Project	IEEE 802.16 Broadband Wireless Access Working Group < http://ieee802.org/16 >	
Title	updating the text related to CSI under CX-Frame scheme	
Date Submitted	2007-09-07	
Source(s)	Wu Xuyong Huawei, Huawei Industry Base, Bantian, Longgang, Shenzhen, China 518129	Voice: +86-755-28976776 Fax: wuxuyong@huawei.com ,
Re:	IEEE 802.16-07/019: Task Group Review: Working Group Draft P802.16h/D2c (2007-08-13)	
Abstract	AI to update the text related to CSI	
Purpose	To consolidate the 16h draft.	
Notice	This document has been prepared to assist IEEE 802.16. It is offered as a basis for discussion and is not binding on the contributing individual(s) or organization(s). The material in this document is subject to change in form and content after further study. The contributor(s) reserve(s) the right to add, amend or withdraw material contained herein.	
Release	The contributor grants a free, irrevocable license to the IEEE to incorporate material contained in this contribution, and any modifications thereof, in the creation of an IEEE Standards publication; to copyright in the IEEE's name any IEEE Standards publication even though it may include portions of this contribution; and at the IEEE

Figure h26—CSI and CMI locations in WirelessMAN-CX

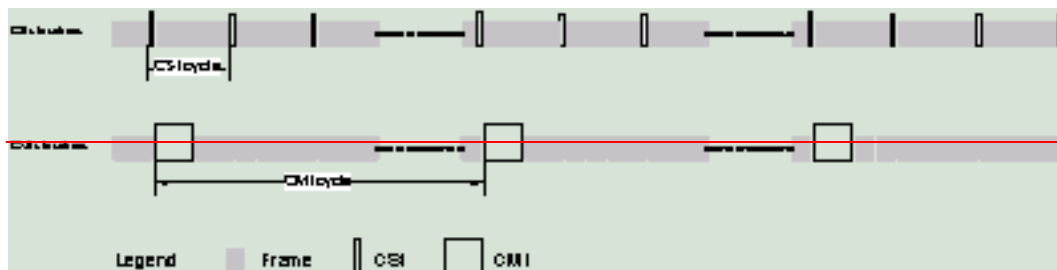
Comment #046 by Kenneth Stanwood in 80216h-07_014r3(15.1.4.1):

Both CSI and CMI are now in cycles of frames which are themselves tied to absolute time.

Reword this paragraph to agree with 15.1.5.3.

Comment #045 by Mariana Goldhamer in 80216h-07_014r3(15.1.4.1):

CSI text shall be up-date to reflect the CXCC structure

Coexistence Control Channel (CXCC) is a logic channel which has integrated multiple sub-channels for a set of interference identification functionality (see 15.3.1). Within CXCC, there are two kinds of basic timing interval element which form up the CXCC, called Coexistence Signaling Interval (CSI) (see 15.1.4.1.1) and Coexistence Messaging Interval (CMI) (see 15.1.4.1.2).

Figure h40—format example of ICSI/OCSI allocation MAP scheduling

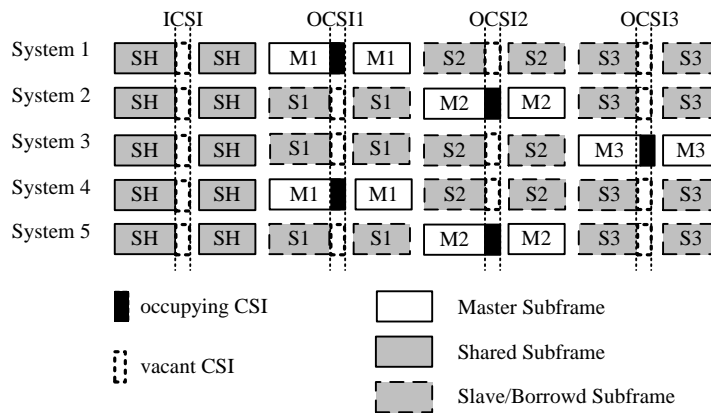
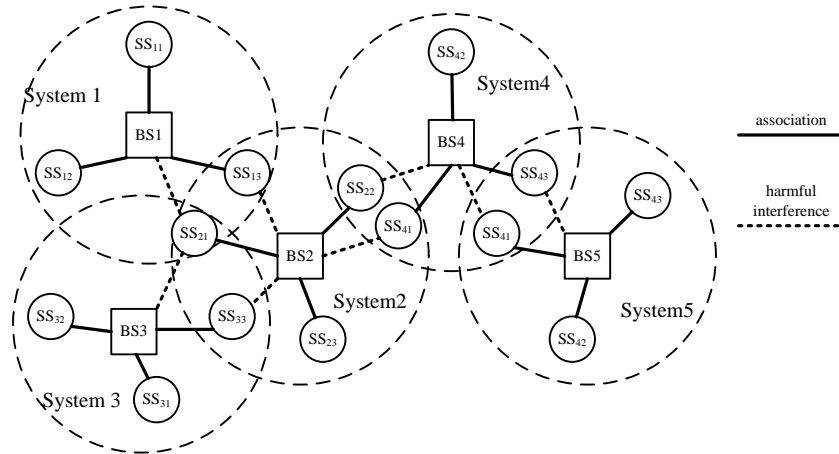
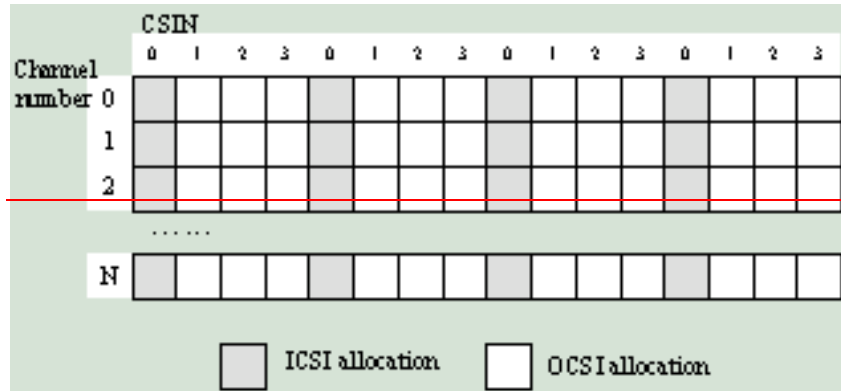
Comment #090 by Kenneth Stanwood in 80216h-07_014r3(15.3.1.1.1):

In Figure h34, CSIN 1 and 3 are used, but the text says a BS could choose 1, 2, or 3 which is incorrect.

Change the example to indicate that the BS with the map in Figure h34 could only choose CSIN 2. In fact, the example would be better if the BS chose one of the more lightly loaded channels like channel 1 or 2.

Group Resolution: Superseded

by resolution of comment 045
